Technical Bulletin

Bulletin Number: 379 Revision Number: R-04

SUBJECT: NEW SOLD OUT PADDLES

MODELS AFFECTED: All Series 90 Venders (See pages 1 & 2.)
All Pre-Series 90 Venders (See page 3.)
Sold Out Paddle Dimensions (See page 4, 5, & 6.)

NEW SERIES 90 SOLD OUT PADDLE

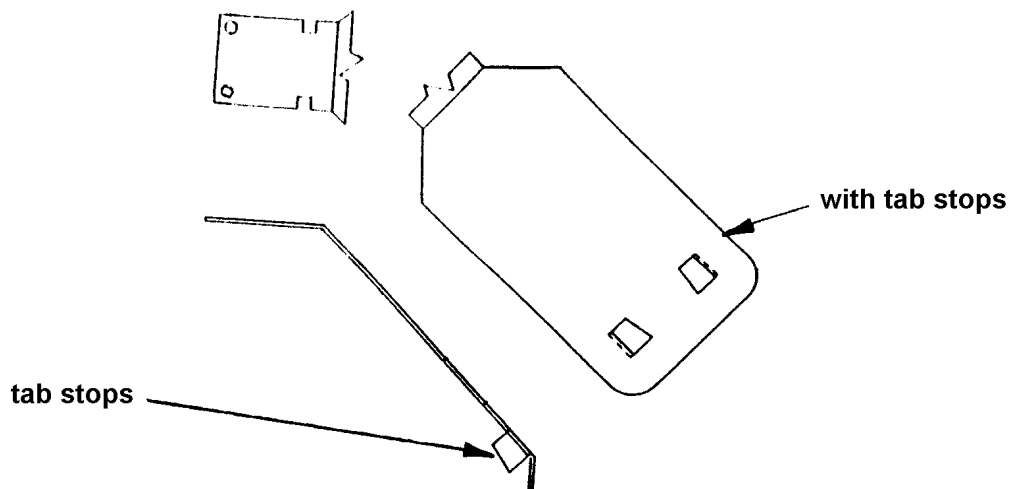
REASON: To add tab stops to sold out paddle to eliminate the special screws used for the paddle stop.

SERIAL NUMBER BREAK: Beginning serial number 1125-6133BR and higher will have the new sold out paddle factory installed.

EXCEPTIONS: Production runs 6134, 6135 & 6136 do not have the new paddle factory installed.

INCLUDES: Production runs 6124, 6128 & 6129 have the new paddle factory installed.

**NEW SERIES 90 SOLD OUT PADDLE
PART # 432,070,19x.x3**

SERIES 90 SOLD OUT PADDLE WITH 1/2" WIDTH INCREASE

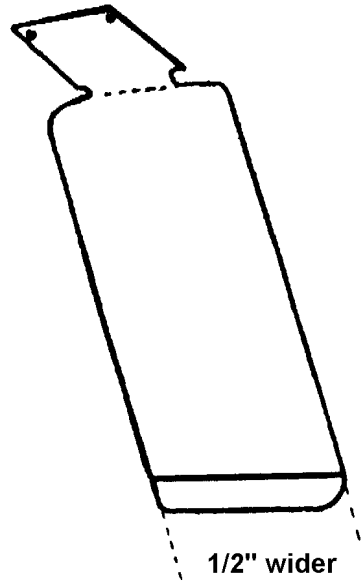
SERIAL NUMBER BREAK: Beginning serial number 0001-6048DP to 1124-6133BR will have the sold out paddle with 1/2" width increase factory installed. Includes production runs 6134BR, 6135BR, and 6136BR. Venders serialized 0001-3162AO to 0001-6048DP do not have the new sold out paddle factory installed.

**SERIES 90 SOLD OUT PADDLE
PART # 432,070,19x.x3**

PRE SERIES 90 SOLD OUT PADDLE

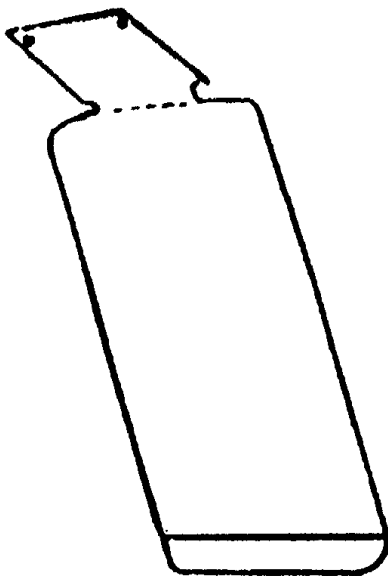
REASON: To add a 45 degree break at the bottom of the paddle.

SERIAL NUMBER BREAK: Beginning serial number 0001-3118BN to 0001-3162AO have the new paddles factory installed.

EXCEPTIONS: Production runs 3124AN, 3125AN and 3126BN do not have the paddles factory installed. Also, venders serialized 1954-3161AO to 2003-3161AO and 2656-3161AO to 2705-3161AO are Series 90 venders.

← 45 degree break starts 3/8" from the bottom

231,070,17x.x3	For T and 1-1/4" Narrow Column
236,070,25x.x3	For T and 1-1/4" Wide Column
280,070,01x.x3	Apple Black Wide Column
381,070,23x.x3	For Accommodator Wide Column
381,070,24x.x3	For Accommodator Narrow Column
